FINAL ENVIRONMENTAL IMPACT REPORT JANUS SOLAR AND BATTERY STORAGE PROJECT

**COUNTY OF COLUSA
COMMUNITY DEVELOPMENT DEPARTMENT
220 12th Street
Colusa, California 95932
State Clearinghouse No. 2024061043
November 26, 2024**

**JANUS SOLAR AND BATTERY STORAGE PROJECT
FINAL ENVIRONMENTAL IMPACT REPORT
TABLE OF CONTENTS**

Appendix A_Marsh

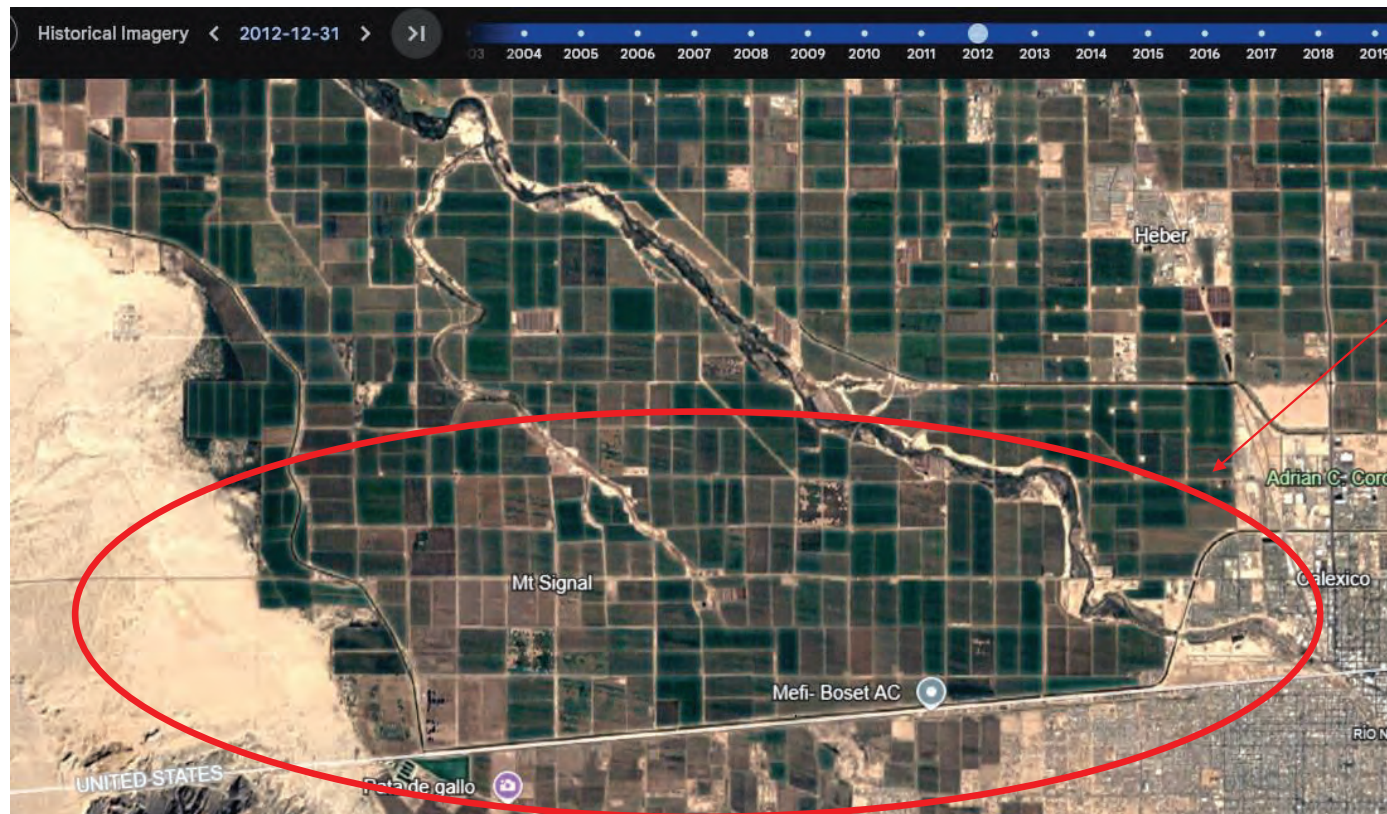
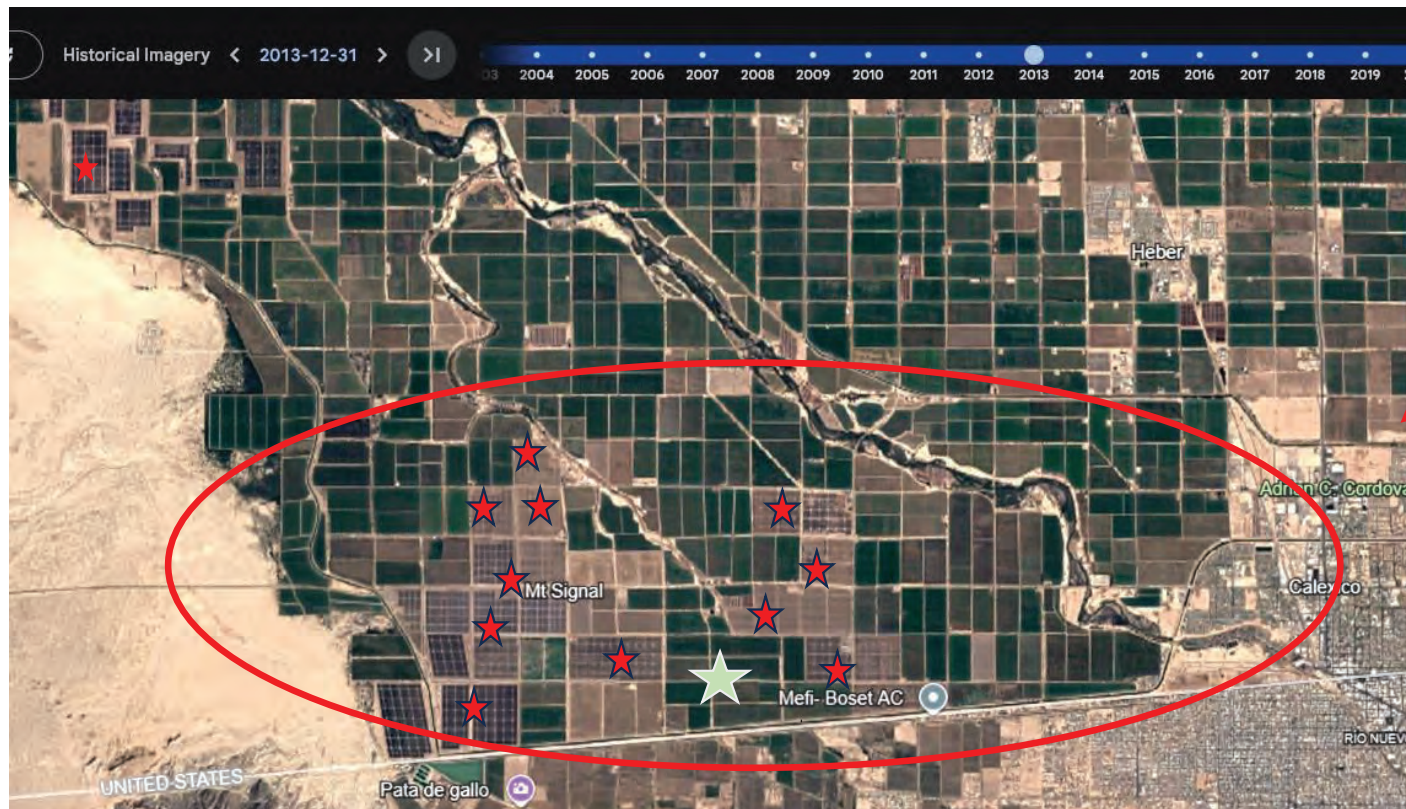
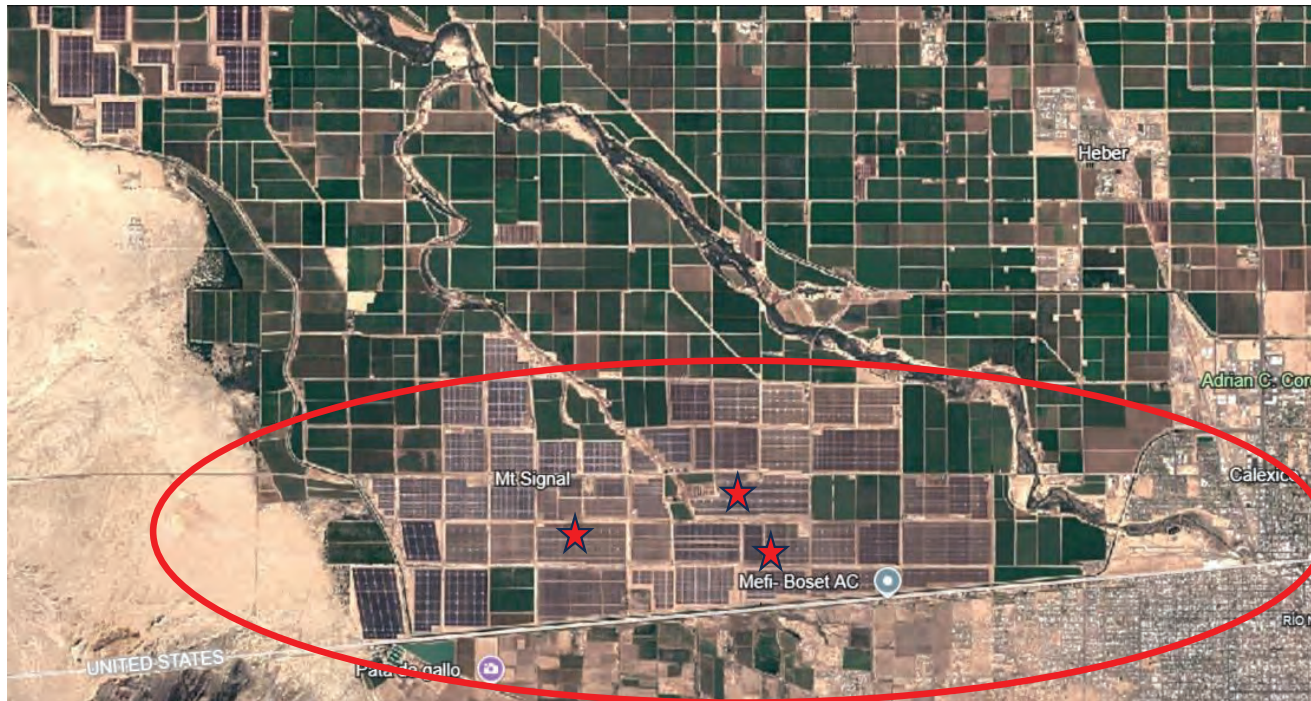
DEIR needs to analyze relative to **zone of influence** and loss of farmlands as required by CEQA. By not including solar developments into the LESA analysis, it leads to incorrect analysis relative to farmland loss as well as foreseeable environmental impacts.

Imperial County California: 2012, ZOI factor

Imperial County California: 2013

Imperial County, California, 2020, ZOI

Focus on
changing
landscape:
Island of
farmland; **GONE**

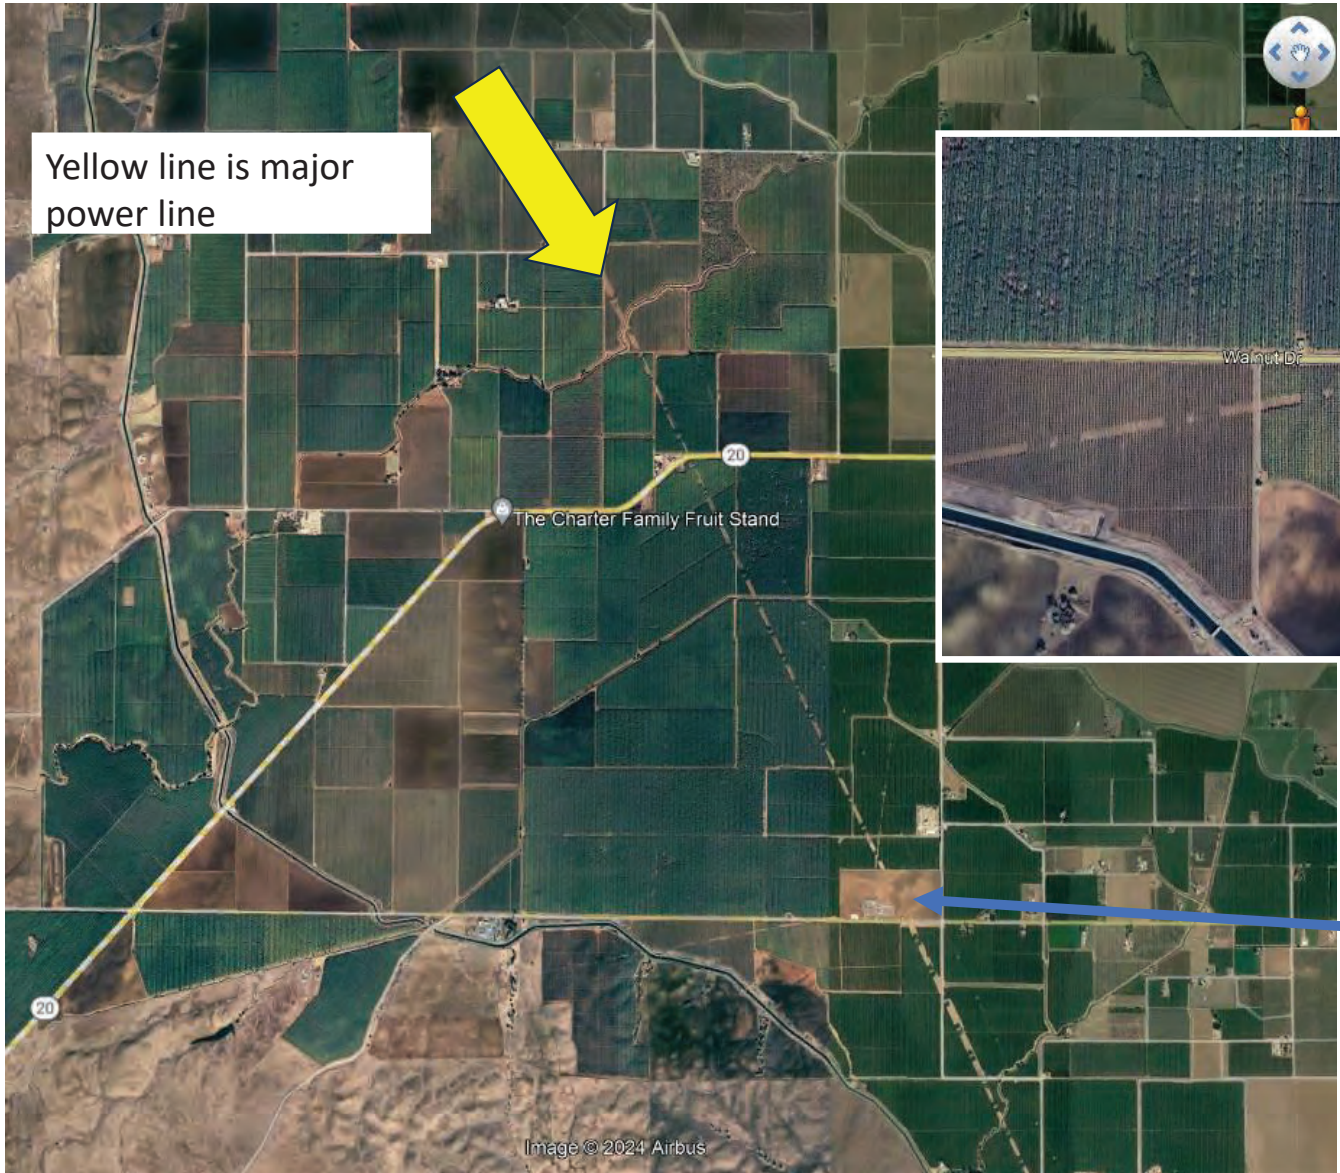
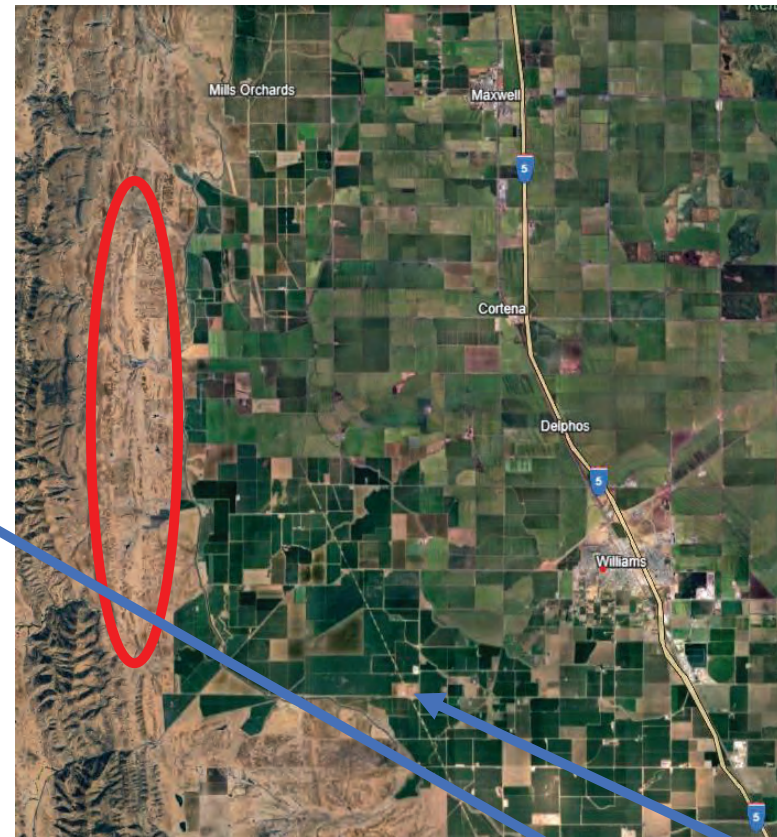
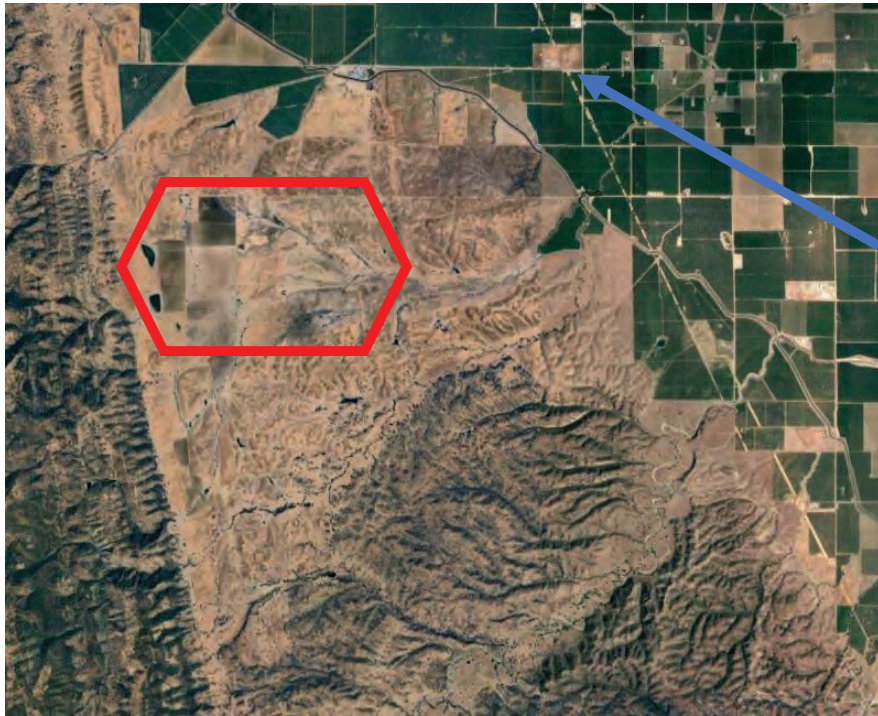
Impact of Solar to Mount Orab, OH, from 2017 to 2022; LESA model in DEIR does not account for solar & ZOI.

Last update (correction) to LESA model Appendices A and B (**dated 2011**) per [Conservation.ca.gov](https://www.conservancy.ca.gov/); Does the DEIR modeling account for changes to solar development; what and how do factor weight impact analysis, ZOI, and are they current and being applied correctly?

- Any Permit, County General plan or ordinance needs to anticipate & correctly model impacts of utility size (large scale) solar developments occurring, particularly if there is a main electrical conduit, substation and/or Gen-tie in nearby.

Red outlined areas may become solar lands and no longer farmland due to zone of influence by initial >600 ac solar facility and Gen-tie in; could also include south of displayed location below.

Appendix A_Marsh

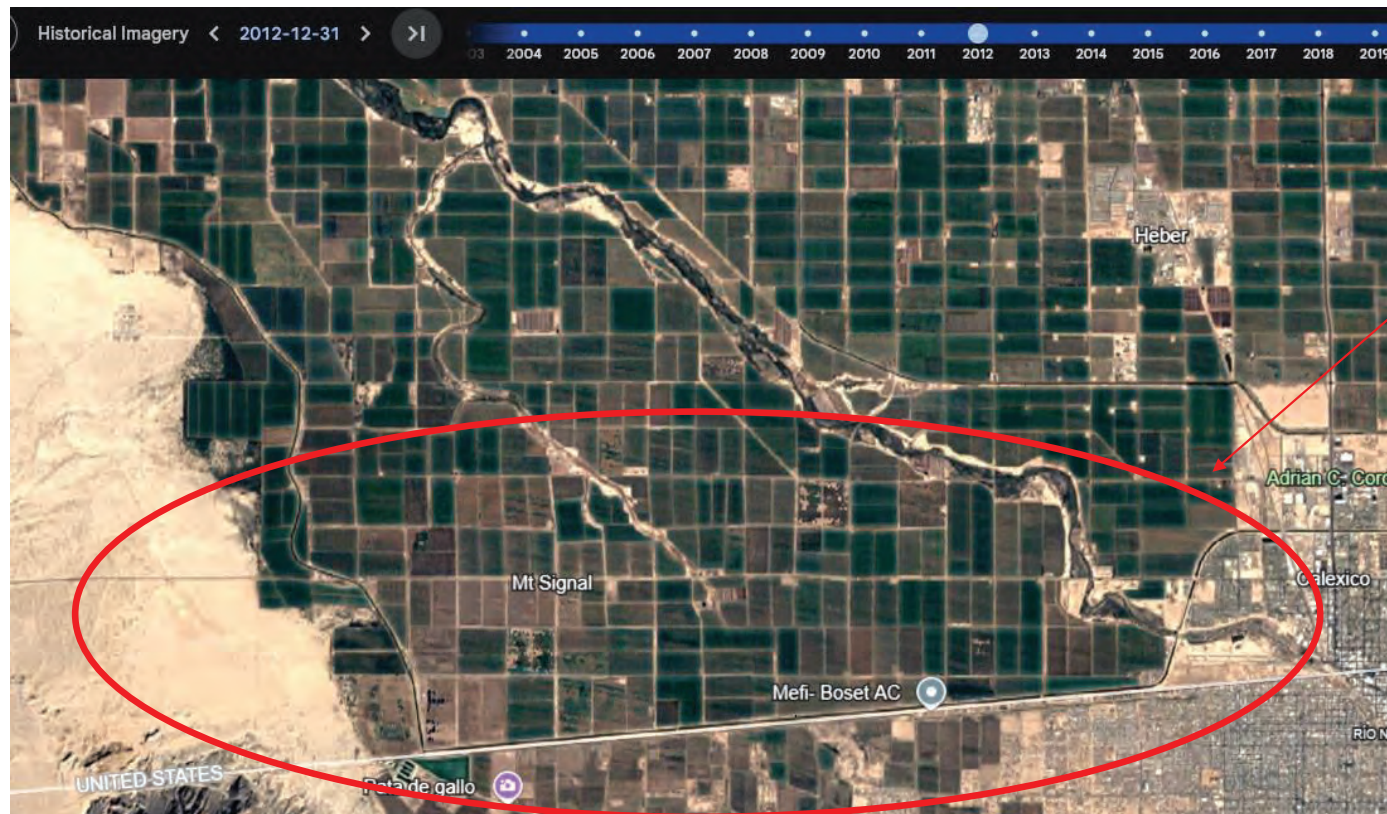
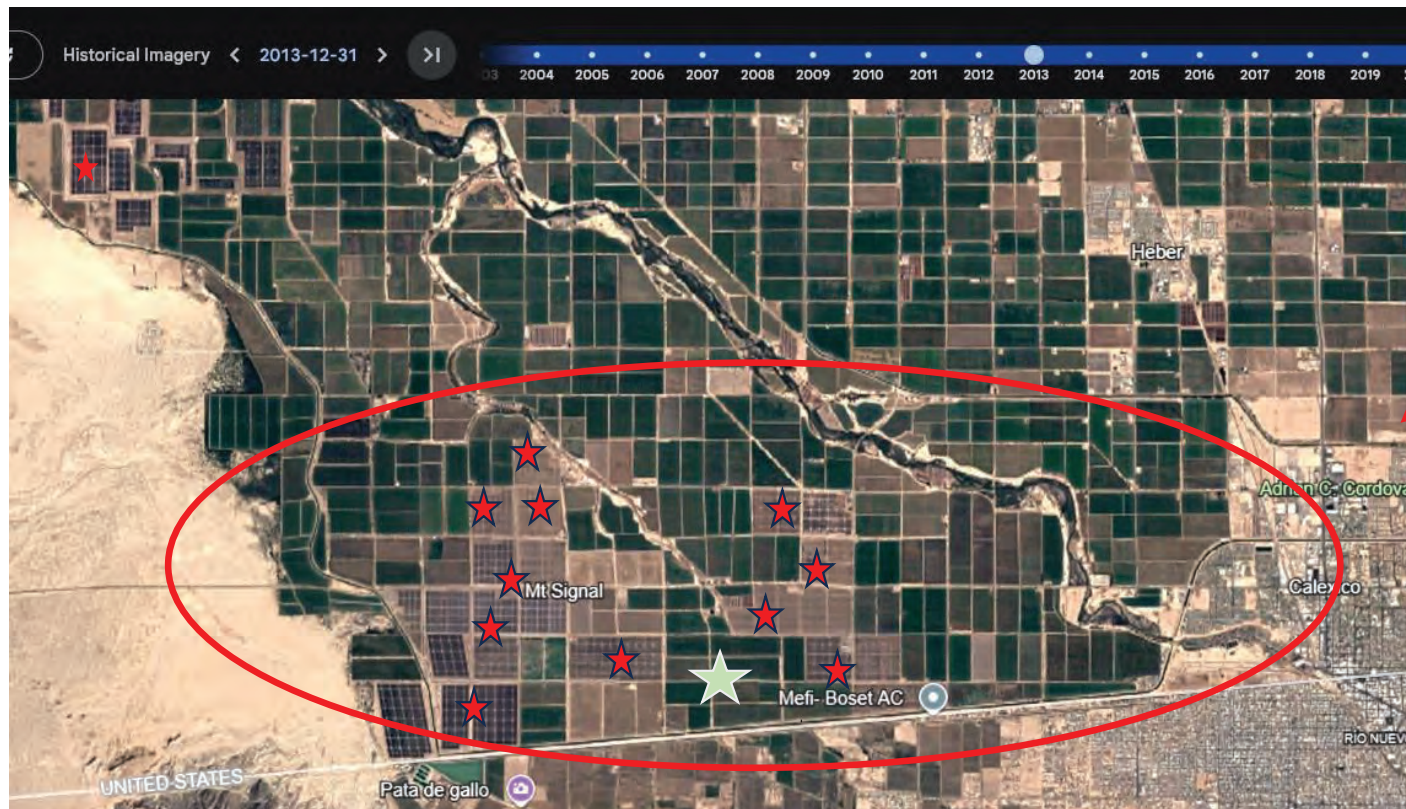
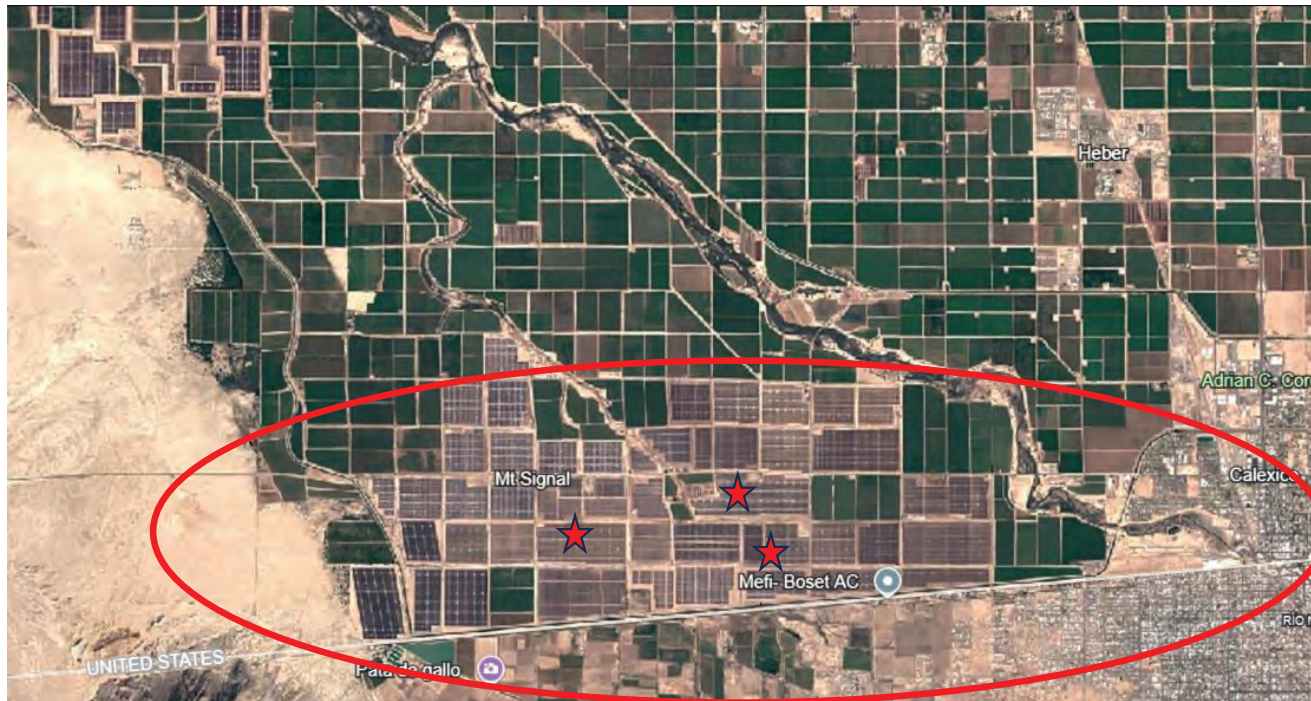
DEIR needs to analyze relative to **zone of influence** and loss of farmlands as required by CEQA. By not including solar developments into the LESA analysis, it leads to incorrect analysis relative to farmland loss as well as foreseeable environmental impacts.

Imperial County California: 2012, ZOI factor

Imperial County California: 2013

Imperial County, California, 2020, ZOI

Focus on
changing
landscape:
Island of
farmland; **GONE**
